Requisition No. EZ899- 220723/A

The following changes in the tender documents are effective immediately. This addendum will form part of the Contract documents.

Project title/Titre du projet
 3000 AIRPORT ROAD
 PENTICTON, BC
 PENTICTON REGIONAL AIRPORT
 PENTICTON ATB
 ROOF SEISMIC UPGRADE
 ROOFING & BUILDING
 ENVELOPE PROJECT

Project No./No. du projet: R.105676.001
 Sheet/Feuille: R-2.1
 Revision no./Lo Révision no.: 6
 4 OF 14

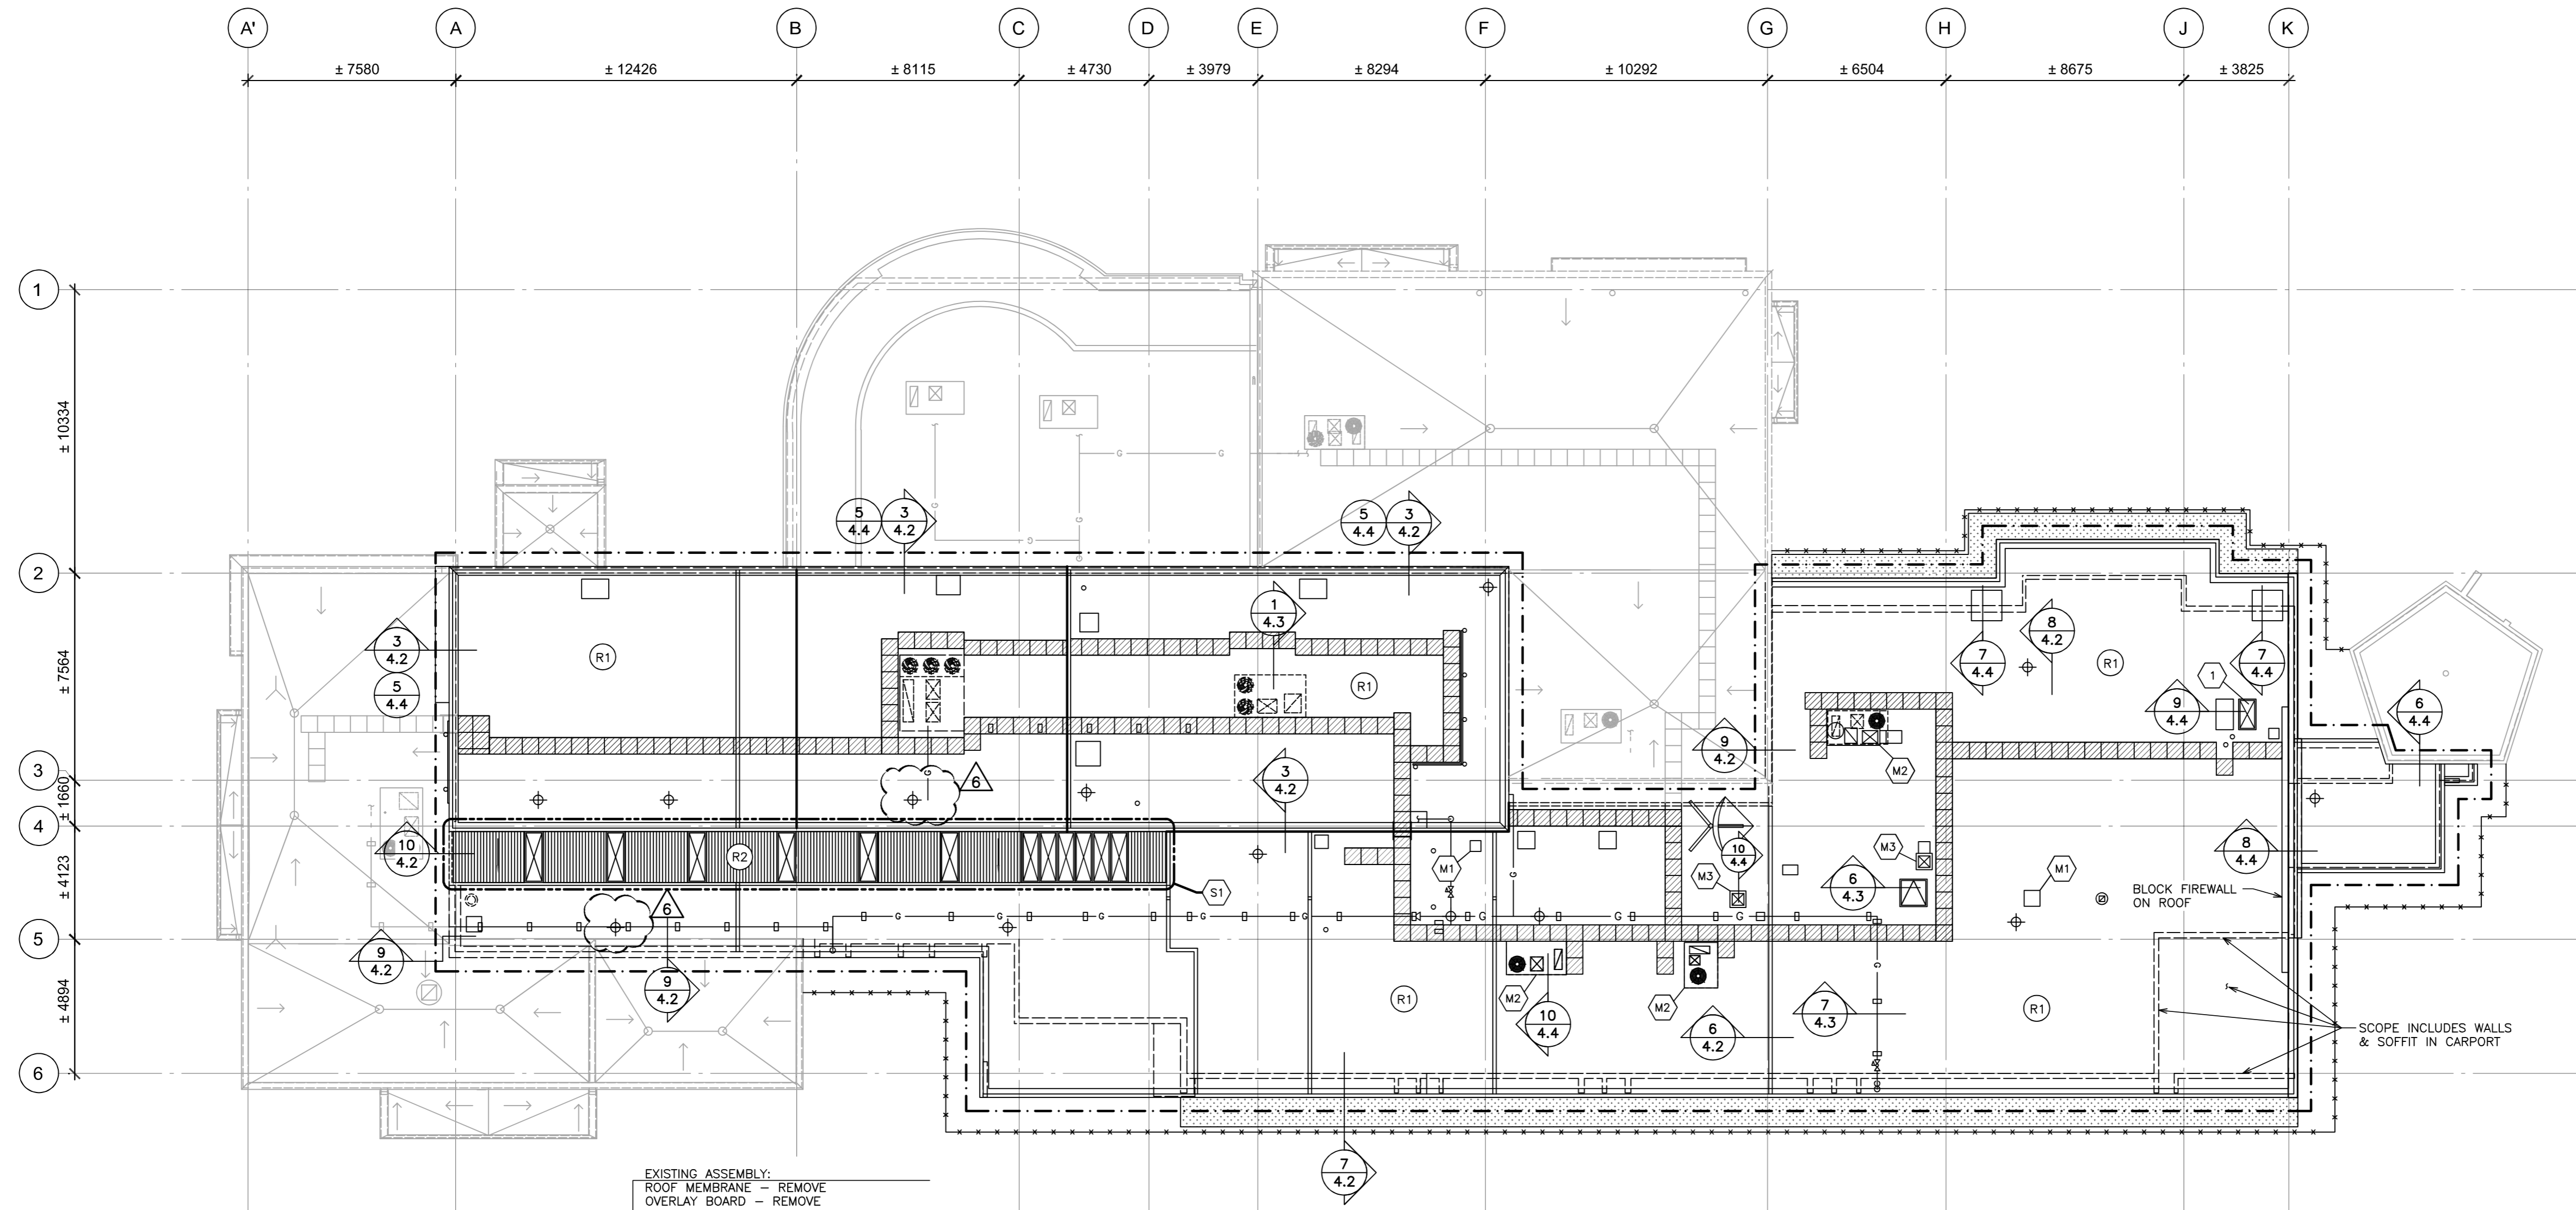
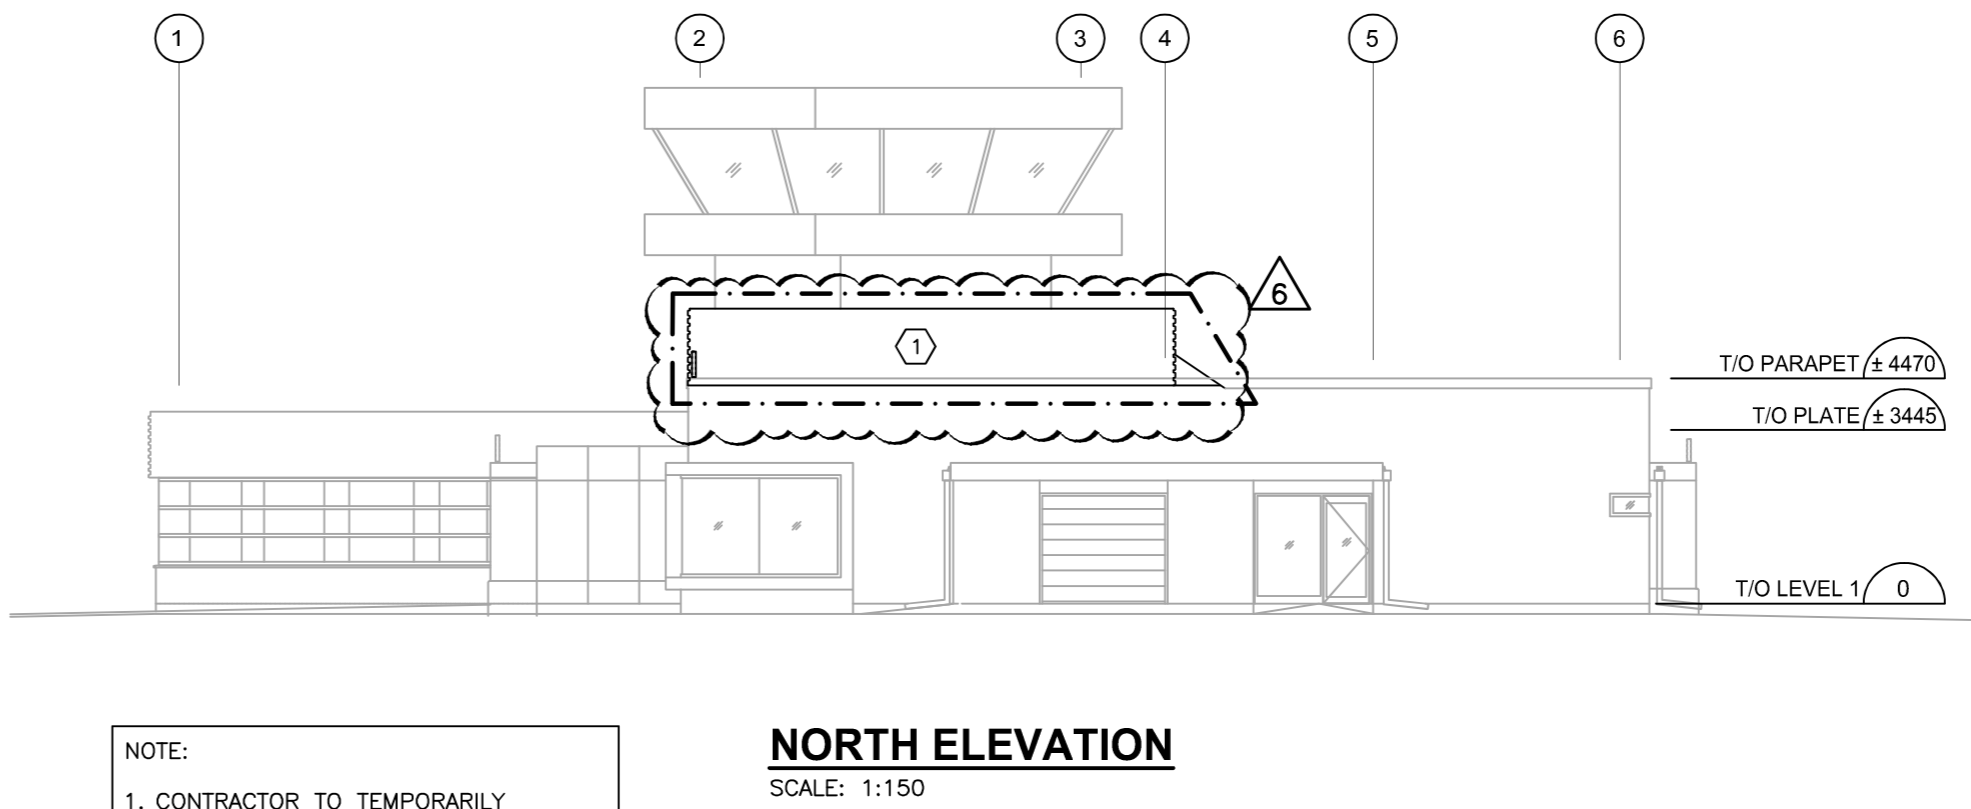
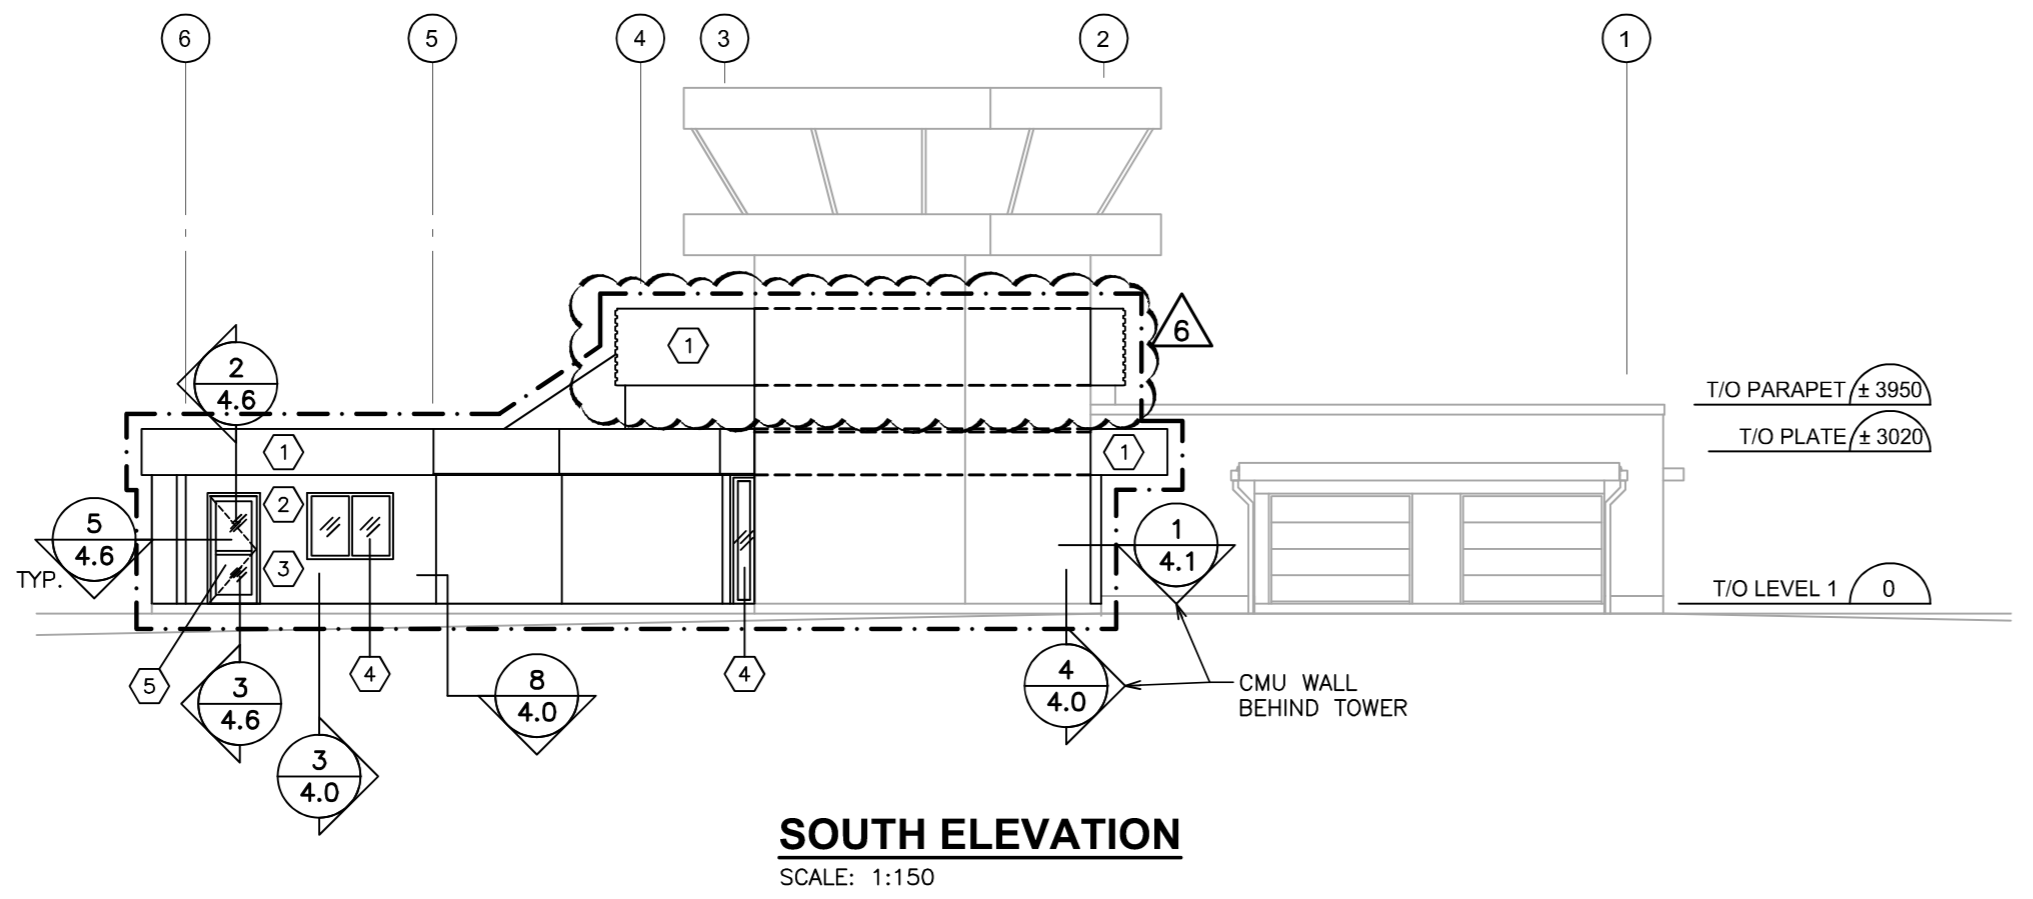
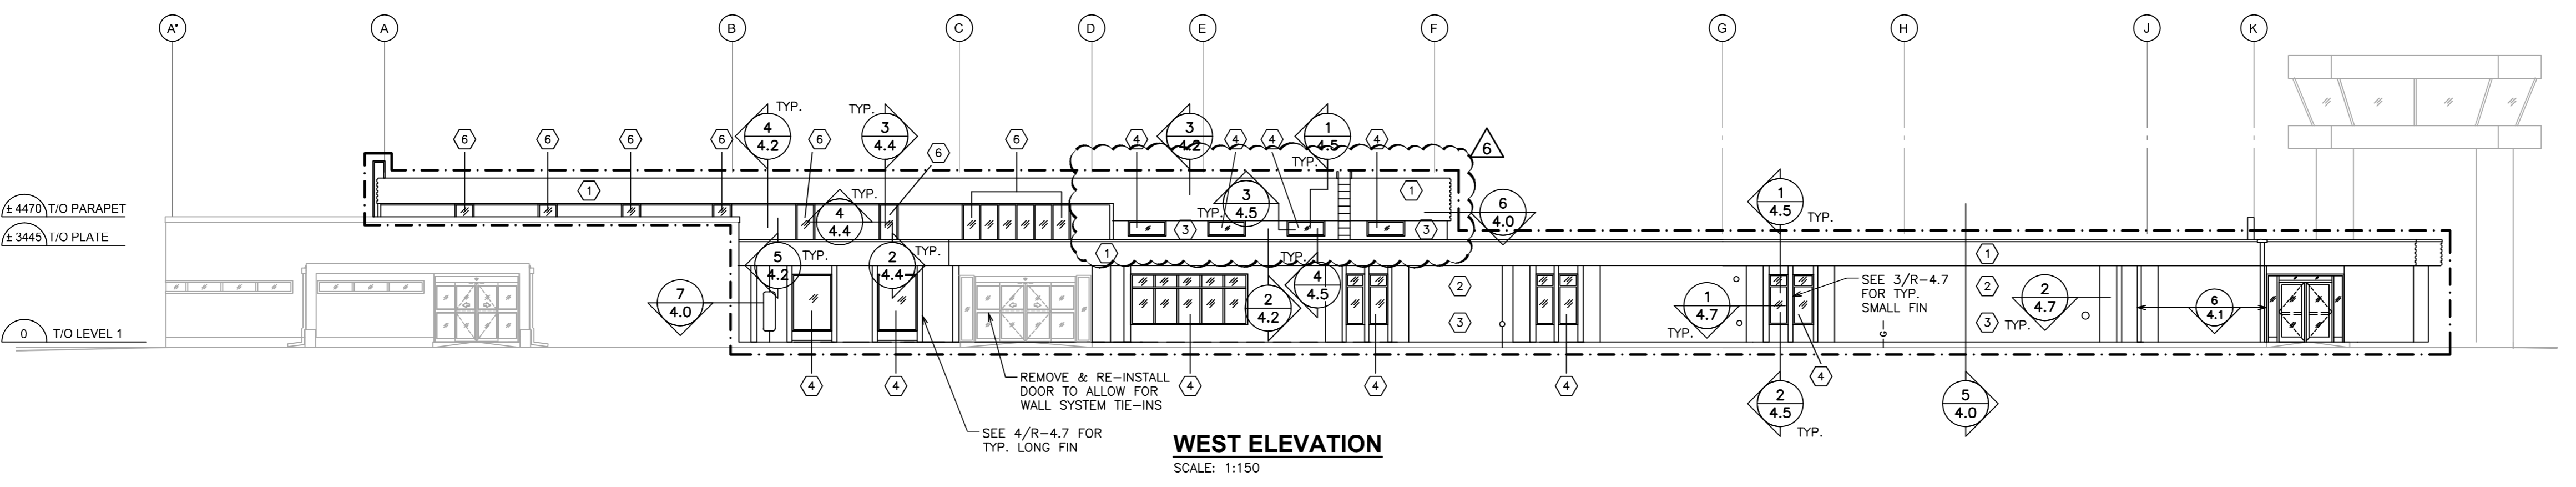
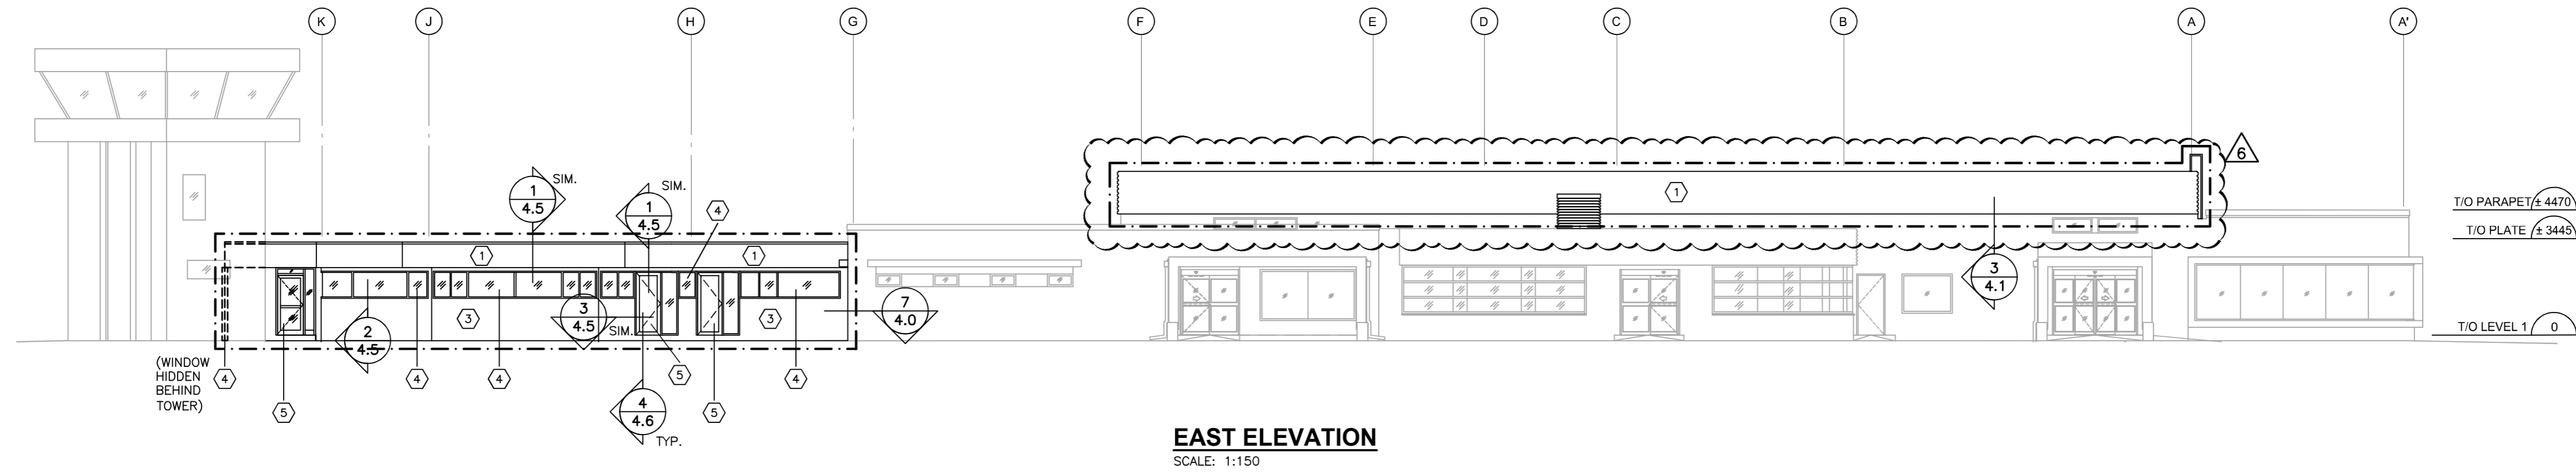
- Drawing R-3.0, revised West Elevation. See attached sheet.
- Drawing R-2.1, clarified drain location on Roof Plan. See attached sheet.

- Q.7 To clarify, as per Addendum 002 A.10, please confirm all roof plywood sheathing is to be removed and replaced – reflecting in an approximate area of 1022 m² based on what is identified on the roof plan, R-2.1.

- A.7 *Area take-off is the responsibility of the bidder. Refer to Addendum 2, Questions 6 and 10. If this does not address the question you are raising, please re-state your question.*

Drawing title/Titre du dessin
BUILDING ELEVATIONS

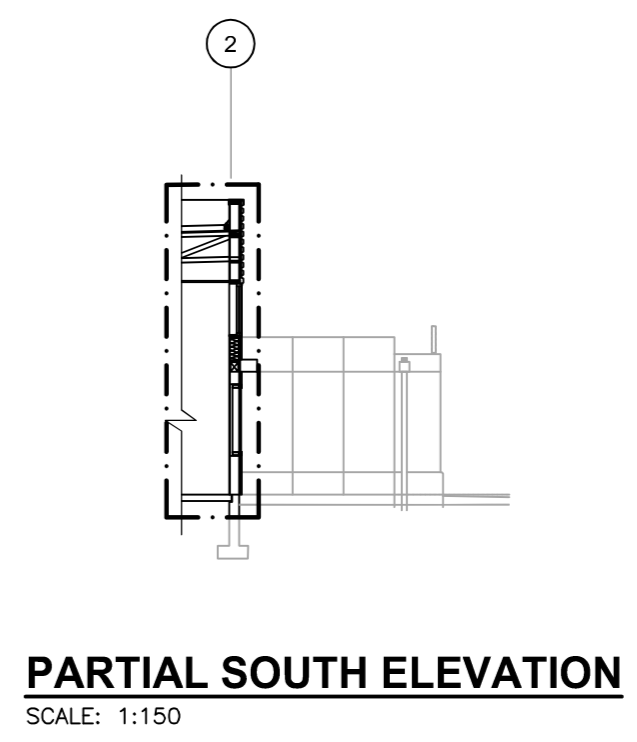
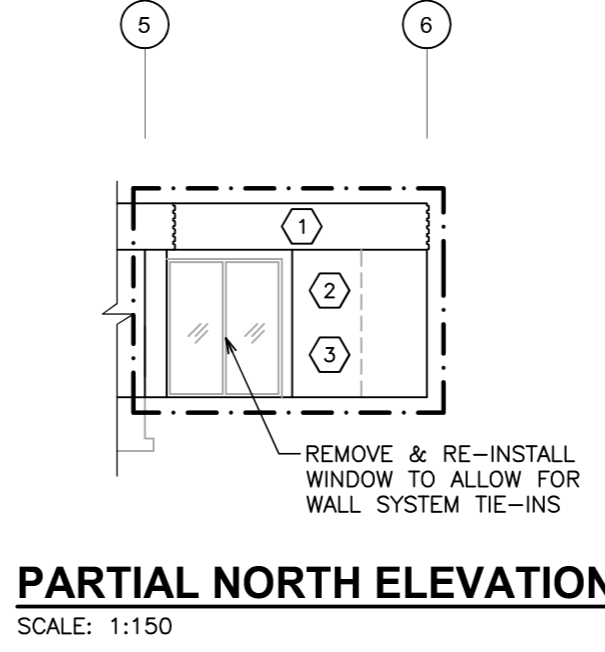
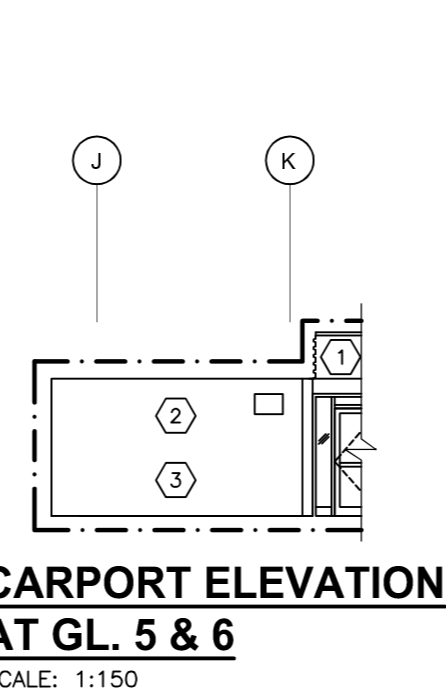
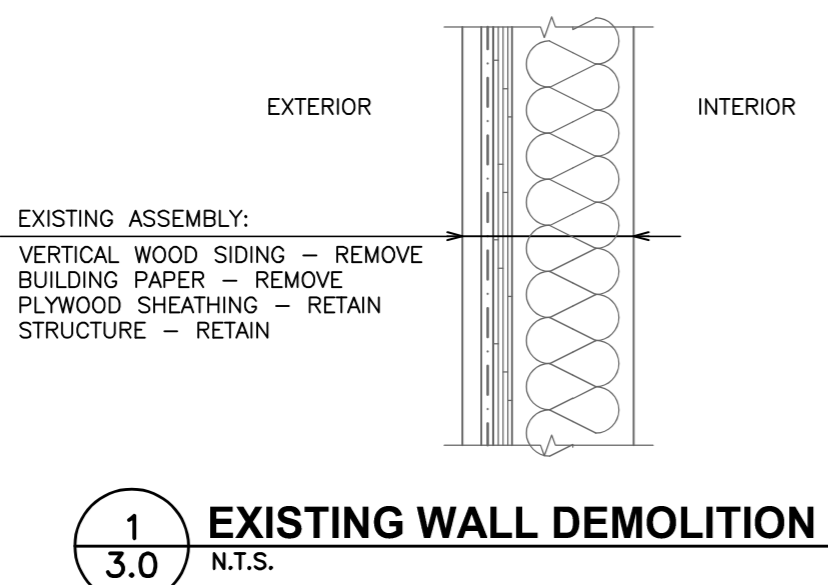
- Q.8 The height of the clerestory fascia cladding on West Elevation is approx. 3' high but on other elevations measures approx. 6' high as per Drawing # A1, please confirm if this is the intent to have a different height?

- A.8 *See revision to West Elevation R-3.0, this addendum. Heights are to be the same.*
- Q.9 Is there any window schedule for the skylights with sizes?
